Sheringham Shoal and Dudgeon Offshore Wind Farm Extension Projects

Apportioning and Habitats Regulations Assessment
Updates Technical Note (Revision D) (Tracked)

Deadline 7

Document Reference: 13.3.1

Title: Figure 1 Overlap of SEP 10km buffer (in 1km increments) with Greater Wash SPA and area outside Red-throated Diver MCA (from Lawson et al., 2016)

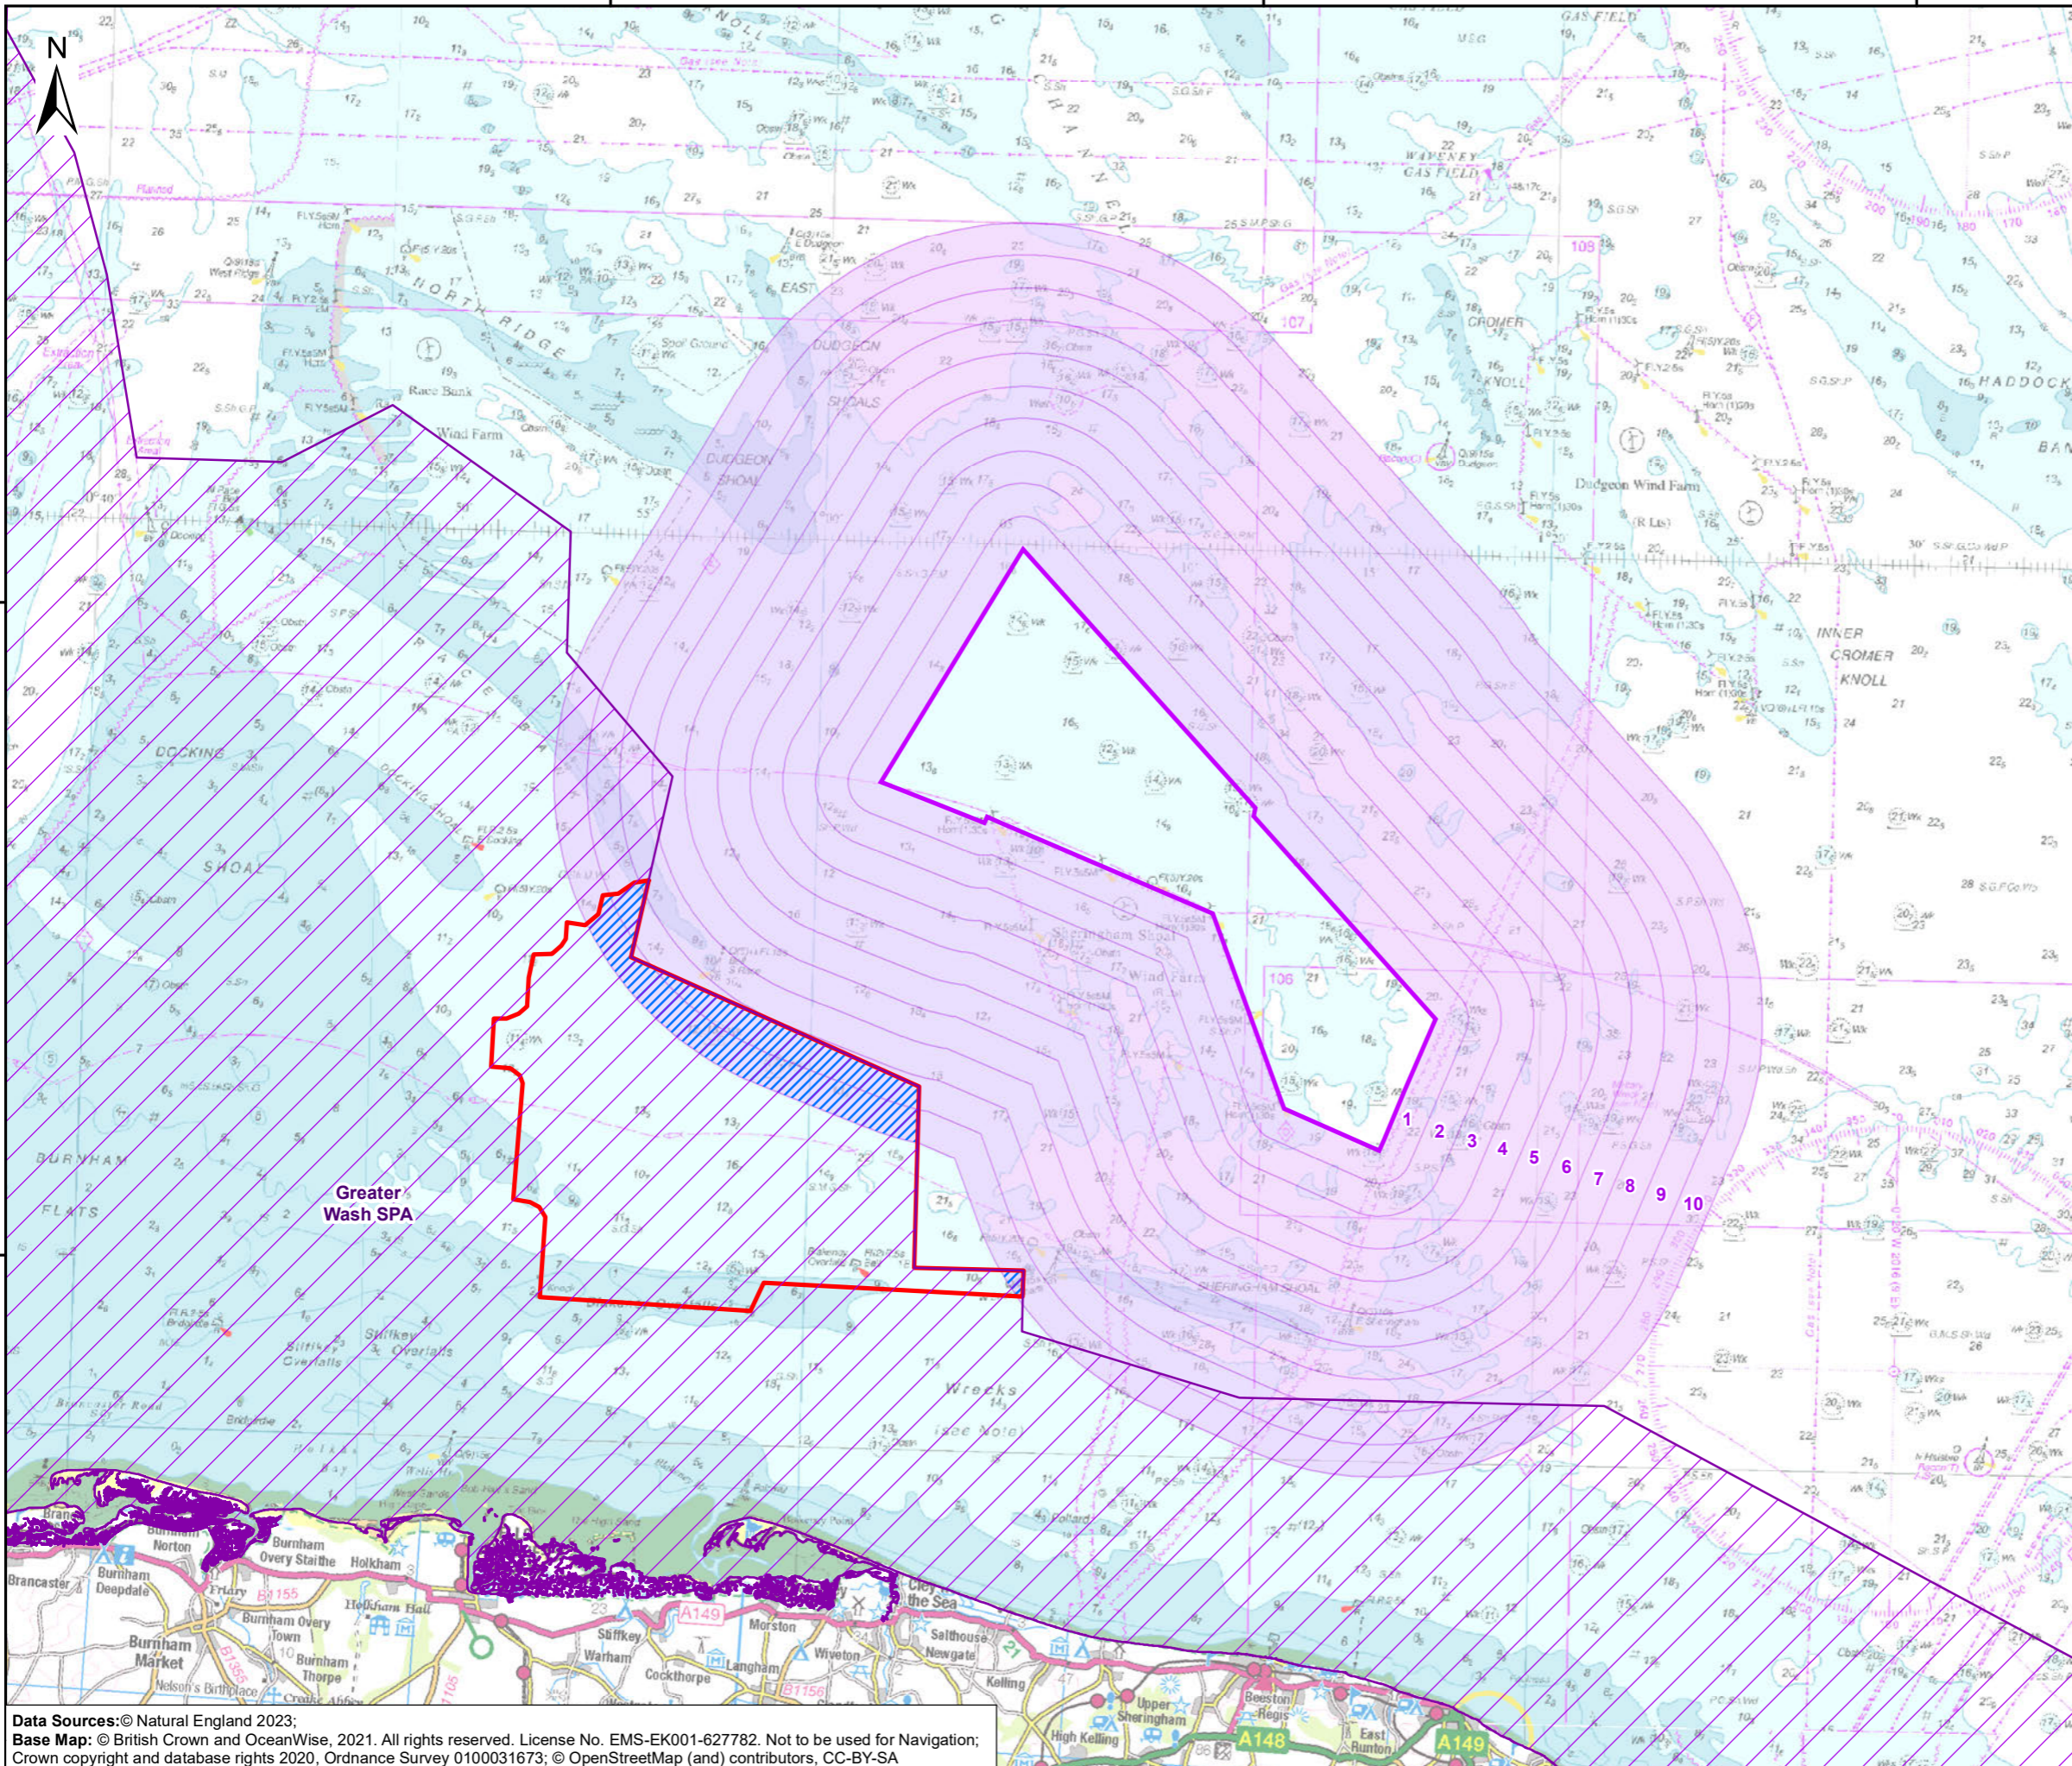
ID	Section of draft document	Paragraph	Natural England comment	Applicant response
			<p>some consideration of the area that falls beyond the MCA line, albeit with the caveats noted above. It is therefore helpful that the Applicant has provided displacement area/SPA % values including as well as excluding this area.</p> <p>B) Natural England note that potential impacts from construction vessels transiting to and from the cable corridors have not been considered within the assessment, presumably due to the fact that the construction port(s) will not be confirmed until nearer the start of construction. However, Natural England consider that due to the fact that use of a port adjacent to either the Greater Wash SPA or Outer Thames is plausible, some further consideration of the possible impacts from construction vessels transiting to and from the ECC should be undertaken.</p>	
18	11. GW SPA RTD	Figures 1 & 2	The legends for Figures 1 and 2 incorrectly show the boundary of the RTD MCA and the area where SEP's buffer zone overlaps the RTD MCA.	The legends for Figure 1 and Figure 2 have been updated.

~~101.~~105. Updated estimates have also been calculated for the area within the SPA within which displacement could occur, based on Natural England's new displacement rates. Minor changes to the areas used for this calculation have all been used in the updated estimates, based on revised GIS analysis (**Appendix 3**). Two estimates have been presented; the first uses the same approach as the **RIAA** [APP-059]. The second uses information presented within the Departmental Brief for GW SPA (Natural England and JNCC, 2016) and which at a meeting on 15 November 2022 the Applicant was recommended by Natural England to investigate further. This method excludes an area of the SPA that is outside of the Maximum Curvature Analysis (MCA) for red-throated diver. The MCA is presented in the Departmental Brief (Natural England and JNCC, 2016) and identifies the areas where significant densities of red-throated diver are likely to be present, based on data presented in Lawson *et al.* (2016). This information contributed to determining the SPA boundary. A section of the GW SPA, which is also within 10km of SEP, lies outside the MCA for red-throated diver (**Figure 1**), i.e. the section of the SPA

which was designated on the basis of a different qualifying species (little gull) and not on the basis of the distribution of red-throated diver. As this area lies outside the zone designated for red-throated diver within the GW SPA, it is considered reasonable to exclude it from the estimate of the displacement area for this species (see [Figure 1](#)).

Title: Figure 2 Overlap of SEP 10km buffer not impacted by existing OWFs

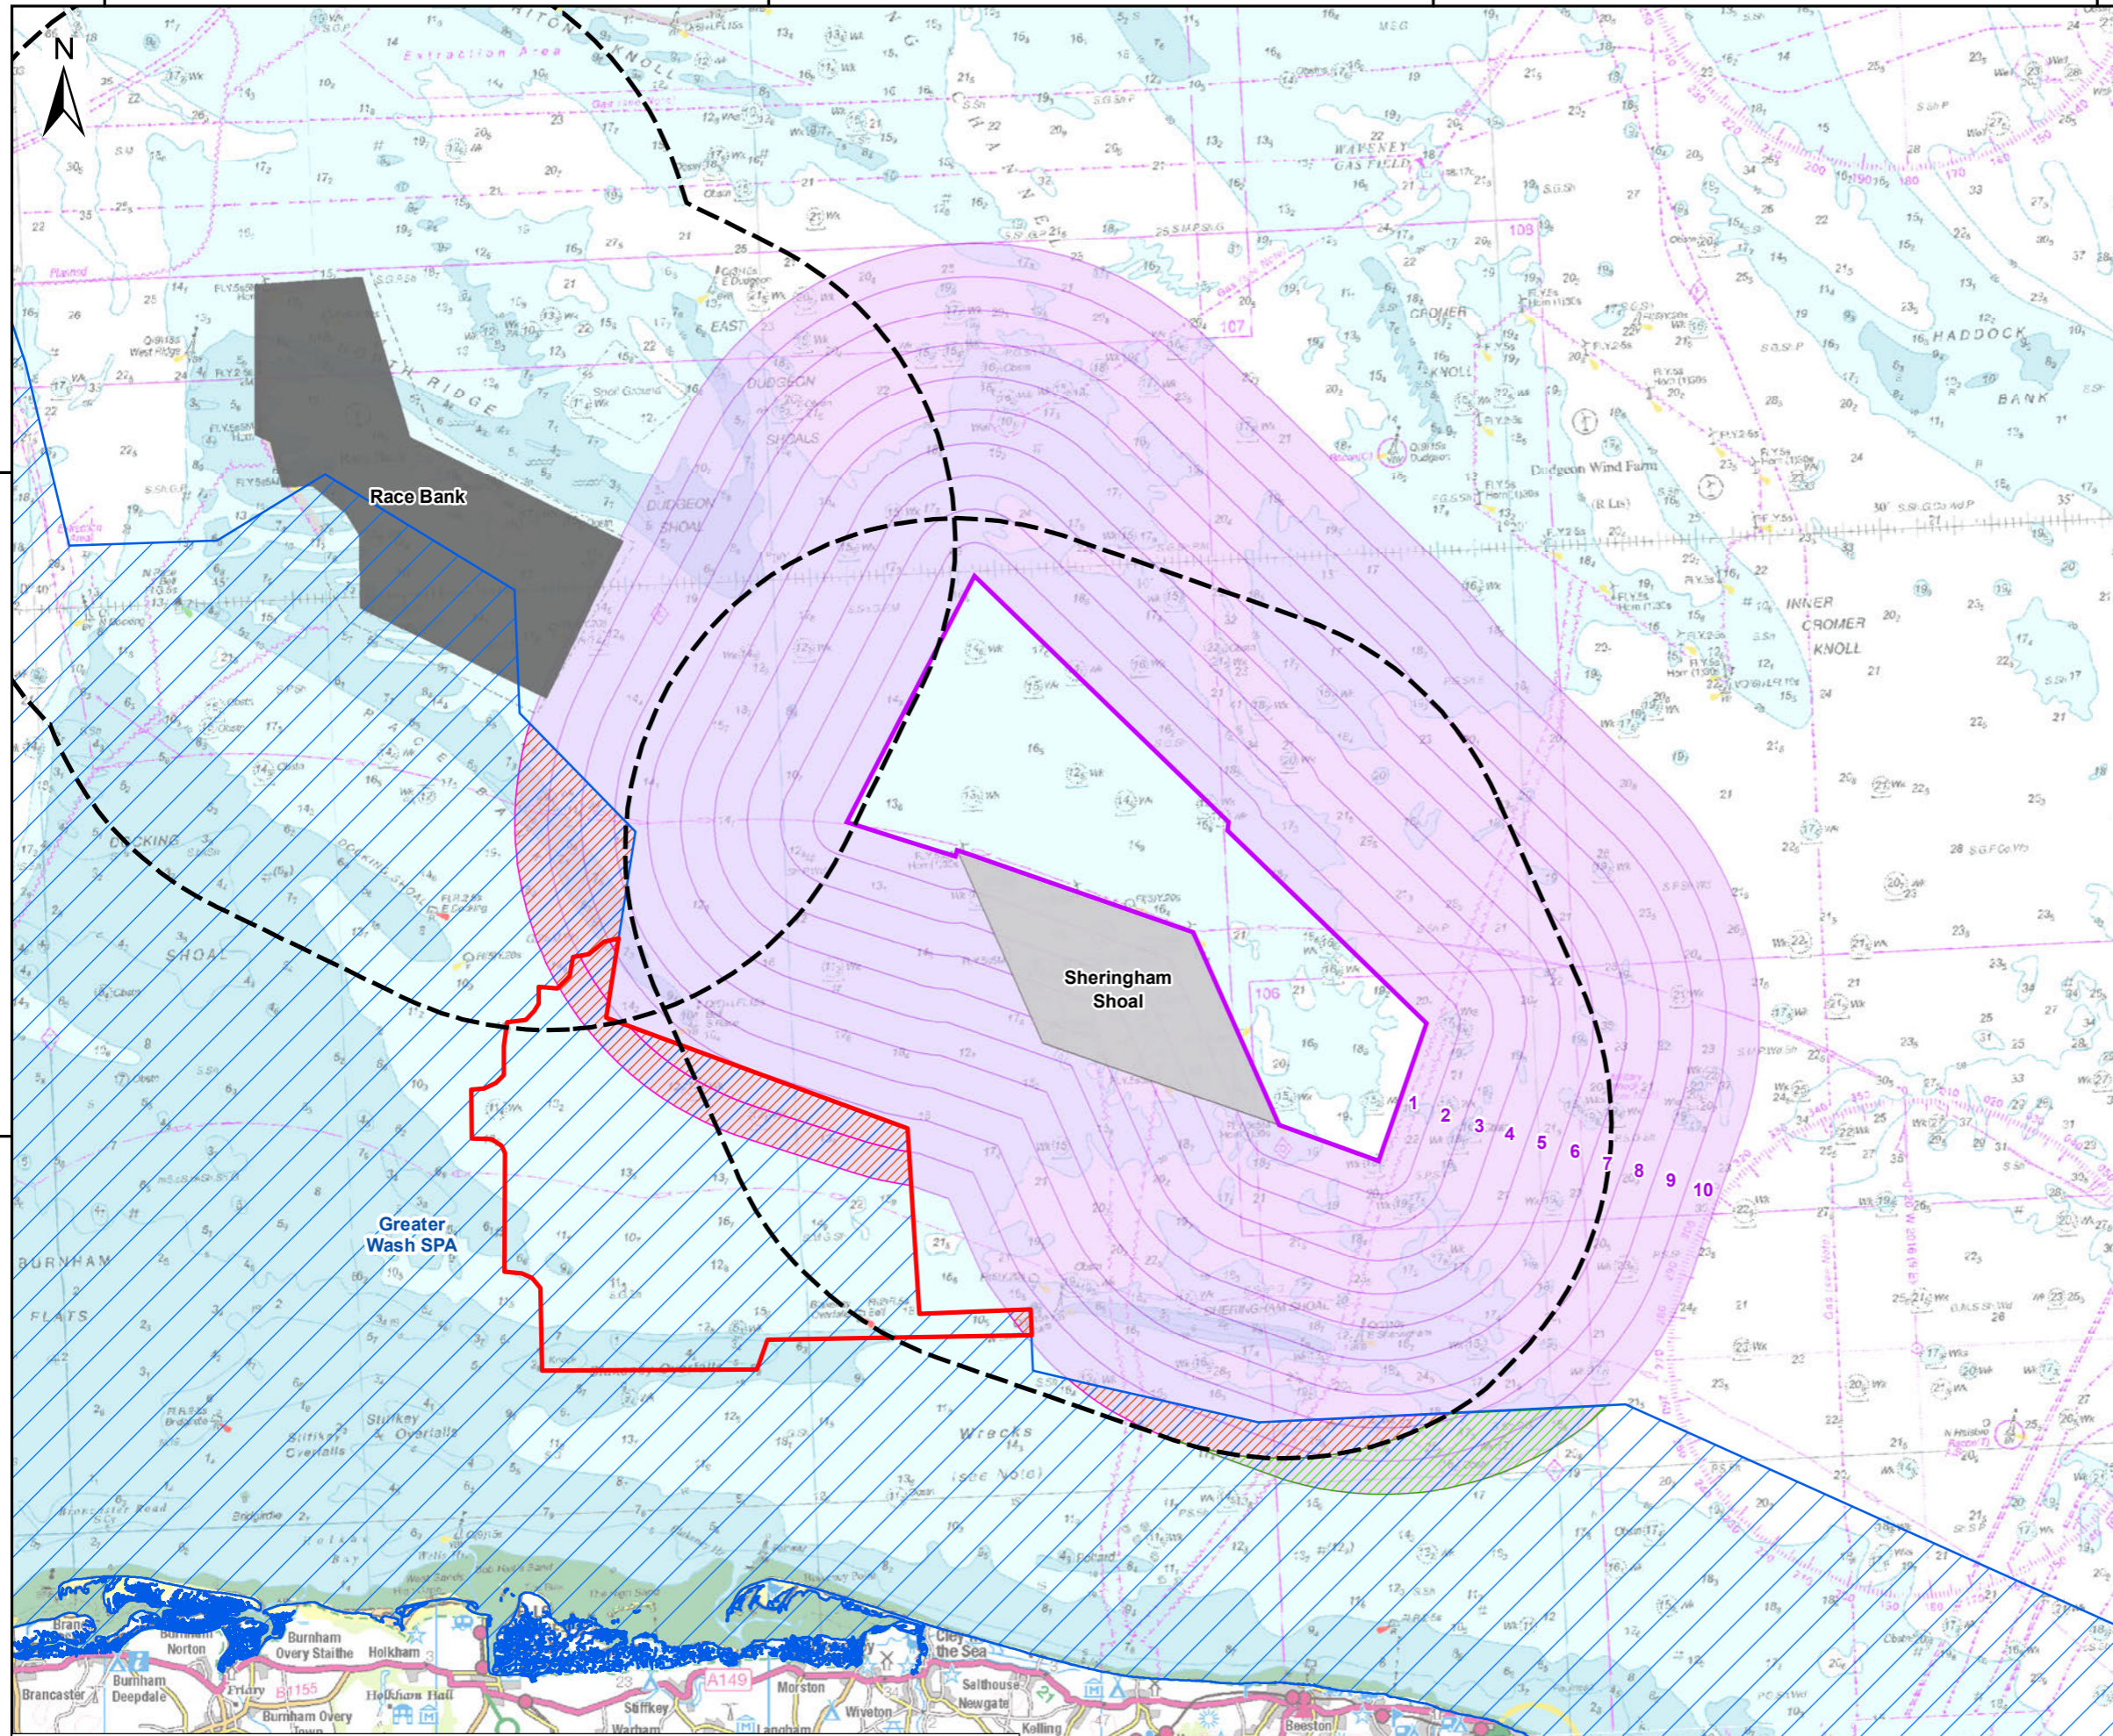
22	11. GW SPA RTD	99	As recognised by the Applicant in the RIAA, excluding areas that overlap existing OWFs from the calculations of area over which displacement could occur as a result of SEP alone does not account for the potential increase in the magnitude of impact in these areas if SEP is closer than the existing OWFs, and therefore this is likely to be an underestimate. Furthermore, even if SEP is further away, it is plausible that it could exert an additional displacement effect. Therefore, Natural England consider that the real project alone impact	The Applicant has updated values in Table 13-3 and Table 13-4 to account for buffer overlap areas where the effect of SEP would be greater than from existing OWFs. This has slightly increased the effective area of displacement from 0.16% to 0.22% (where all of the SPA boundary is included) and 0.12% to 0.17% (where the area outside of the red-throated diver MCA is excluded).

i.e. within the red-throated diver MCA and outside areas within 10km of existing windfarms, is 6.03km² or 0.17% of GW SPA; the net impacted area is shown hatched green on **Figure 2**. As DEP is more than 10km from the Greater Wash SPA, no effects are predicted for this OWF.
